Access Compliance Report Public Rights-of-Way (Pedestrian Signals)

Main Street: **UNIVERSITY_DR** Cross Street: **IRVINE_AVE** Location: **S**

ADA ID: **SGRK211018113630** Signal Type: **One Push Button-Non APS** Overall Compliance: **No** Severity Scores: **BTN 1: 35** **BTN 2: N/A** **No BTN: N/A**

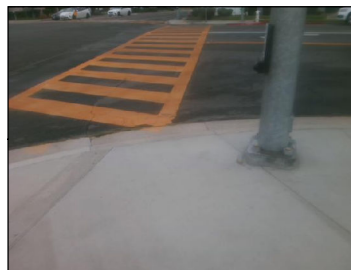
OC Std/PROW: **R404.2, R404.3, MUTCD 4e.08**

Possible Solutions: Replace Signal Push Button With APS Button. Remove and Replace Clear Space.
